CITY OF ALBUQUERQUE

RE: Jomar/Martinez Residence 2123 Candelaria NW Grading Plan Stamp Date: 8/1/18 Hydrology File: G13D035

Based on the submittal received 8/1/18, the Grading Plan cannot be approved for Plat or Grading Permit until the following are corrected:

FLAT GRADING SCHEME

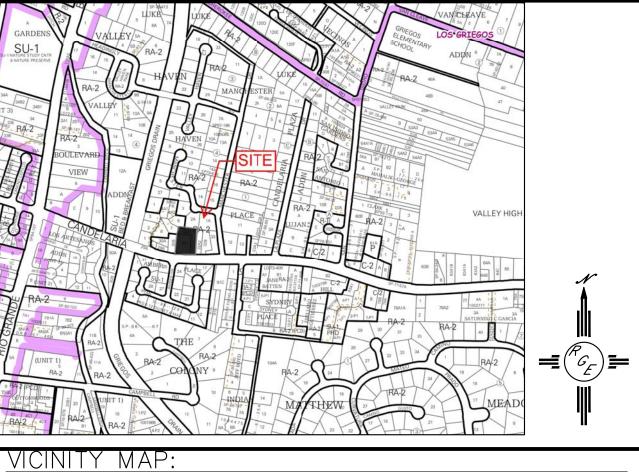
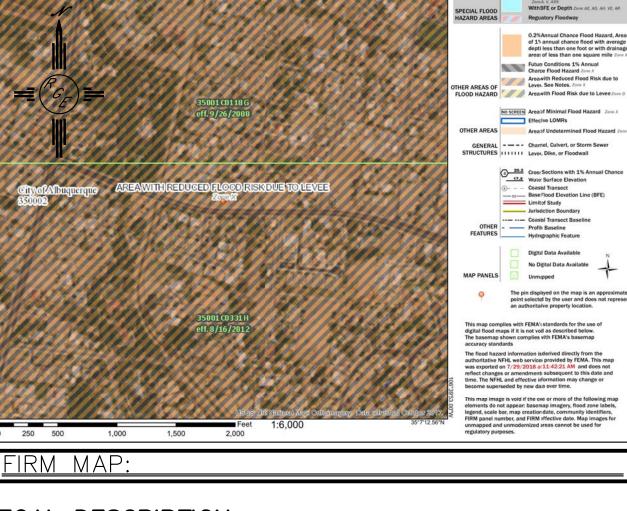
1. Include project benchmark.

2. Provide topographic survey for the adjoining properties (~10' across the property line); ensure your proposed grades tie in at the property line.

3. Add note on the plan that "No work shall be performed in the public ROW without an approved Work Order or Excavation Permit."

4. On the Plat, provide a drainage easement over the ponds and annotate using the <u>Plat Drainage</u> <u>Easement Note</u>. This note replaces the need for a separate drainage covenant.
